21555 Non-Transparent PCI-to-PCI Bridge

Specification Update

December 2002

Order Number: [278337-008](#)

Figure 1. Node Boundary

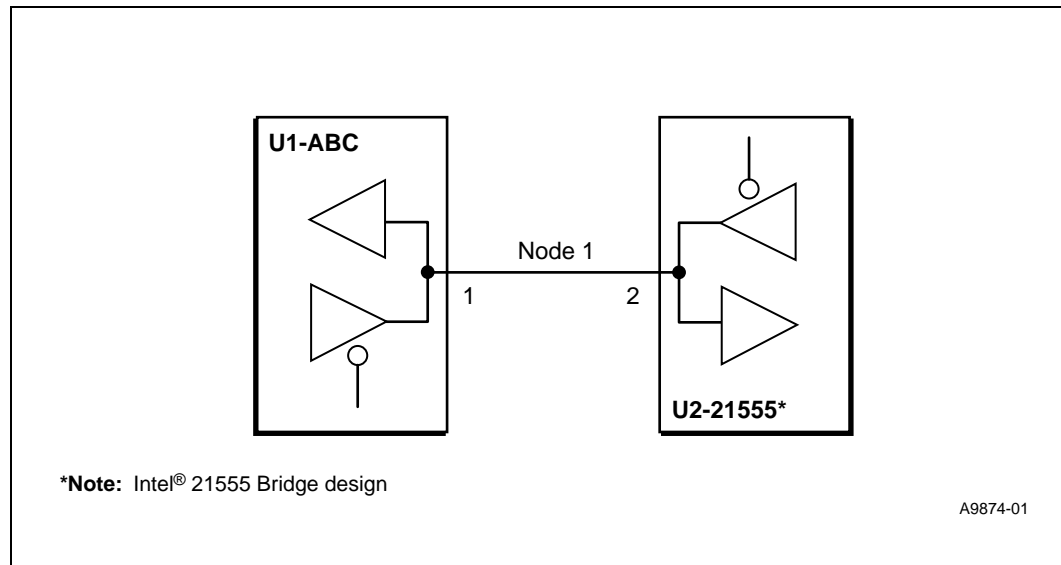
Problem: There is a one cycle delay before valid BSDL data is pushed out to the pins. The problem is due to an incorrect inversion in the equation that generates the JTAG update.

Implication: The parallel output data from any bi-directional pins, purely output pins or control cells, will be driven out exactly one clock after the UPDATE state. This is in violation of the IEEE1149.1 Specification.

To understand the potential issue in detail, refer to the diagram below. Node 1 is a bi-directional node, with U1.1 and U2.2 connected as shown. Assuming that U1 is an IEEE1149.1 compliant device, that U2 is the 21555, and that the control cells of the 21555 were set during the vectors to enable the driver of U2.2 to drive to U1.1 (receiver). When switching drivers from U2 to U1, U2 should tri-state its driver prior to, or at the same time as, U1 enables its driver. Since the 21555 UPDATES its Parallel Outputs one clock late and the control cells which enable U2's drivers are Parallel Outputs which again updates one clock cycle late then U2.2, which will be driving at the same time U1.1 is driving. This contention will happen for one TCK cycle, until U2 UPDATES its parallel outputs. The period of this contention is dependent on the TCK frequency rate.

A remedy to the 21555's late UPDATE is to ensure the chained Boundary Scan tester's vectors do not switch bus driver directions in one vector. This means that one vector should disable U2's driver, and the next vector should enable U1's driver. ATPG vectors typically are not manually manageable in this way and this requirement may force an engineer's manual intervention. No single stepping of test clock through the TAP State Machine should be allowed with the 21555 in the boundary scan chain. The resulting contention would increase the potential back drive time, increasing the possibility of device damage.

Workaround 1: In-Circuit testers should test for the parallel output data to be on the pins of the chip, at least one clock after the UPDATE state. Typically Automated Test Pattern Generator (ATPG) test vectors will test for this state upon exiting the UPDATE state. This test should be delayed one clock from the ATPG vectors. Also, In-Circuit testers should ensure that data is driven onto pins of the 21555, one clock after UPDATE, to avoid any potential of back driving a pin.

Workaround 2: Standalone boundary scan testers and In-Circuit testers performing chained boundary scan tests, should understand that the Parallel Output UPDATE data, being delayed by one clock, may cause bus contention and back driving during that one clock period, assuming the vectors change bus driving sources in one vector. This is because in chained boundary scan tests, all components execute TAP instructions in Parallel (or lock step), and vector generation algorithms optimize the number of vectors.

Status: Fixed. This behavior has been corrected in the 21555AB/BB Step A3 device.

Figure 12-1. Signal trst_I States

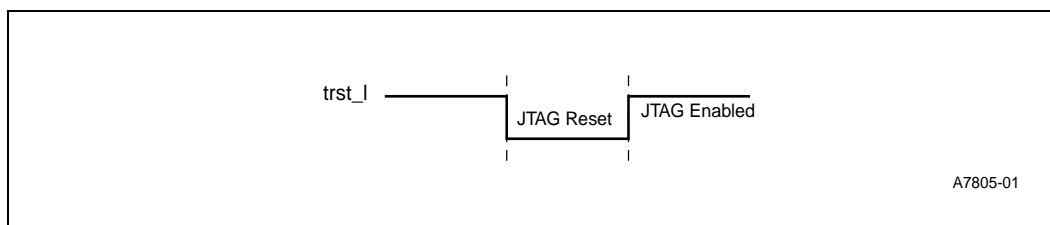
13. Change to Initialization Section 12.2.1 and JTAG Description

Issue: Change to second paragraph. Also made a change to normal operation description note for JTAG below Figure 12-1. The section now appears as follows:

The test access port controller and the instruction register output latches are initialized and JTAG is disabled while the **trst_I** input is asserted low (see Figure 12-1). While signal **trst_I** is low, the test access port controller enters the test-logic reset state. This results in the instruction register being reset which holds the bypass register instruction. During test-logic reset state, all JTAG test logic is disabled, and the device performs normal functions. The test access port controller leaves this state only after **trst_I** (low) goes high and an appropriate JTAG test operation sequence is sent on the **tms** and **tck** pins.

For the 21555 to operate properly, the JTAG logic must be reset. The controller resets:

- Asynchronously with the assertion of **trst_I**.
- Synchronously after five **tck** clock cycles, with **tms** held high.

Note: Prior to normal 21555 operation, this signal must be strobed low or pulled low with a 1kΩ resistor.
